Effects of diversions for the Comanche Peak Nuclear Project on the ecological health of the Brazos River

Trungale Engineering & Science
April 4, 2009

Figure 1 Frequency of failing to meet targets under natural, current and proposed flow conditions

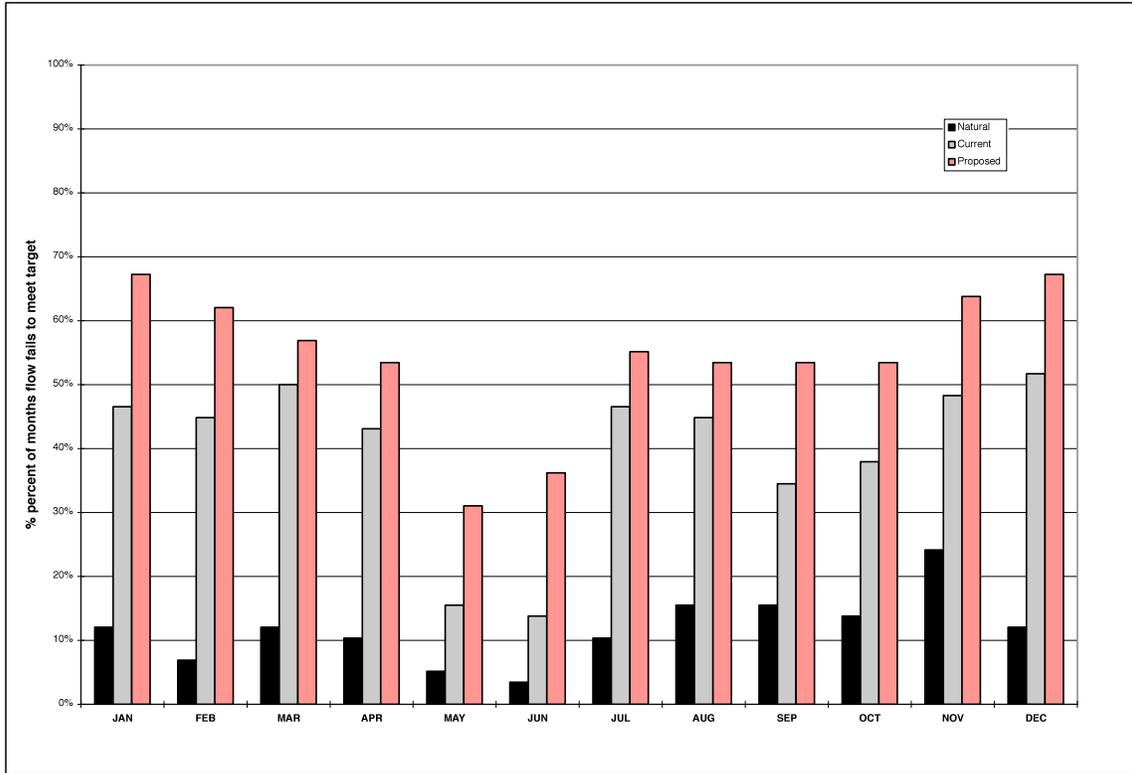
Finally the frequency of failing to meet the necessary flow conditions would be substantially increased with the implementation of the proposed water development plans need to supply water for the Comanche Peak project. Frequency of drought conditions is defined as the number of months in which the target flows are not meet. These frequencies are presented in Figure 1 as the percent of months over the 56 year WAM simulation period during which the flows would be expected to be below recommended levels. Clearly there are times when even under natural conditions the targets would not be satisfied, however these occurrence which would have been relatively infrequent (about 10% of the time) under the natural flows will become the dominate condition under the proposed plans.
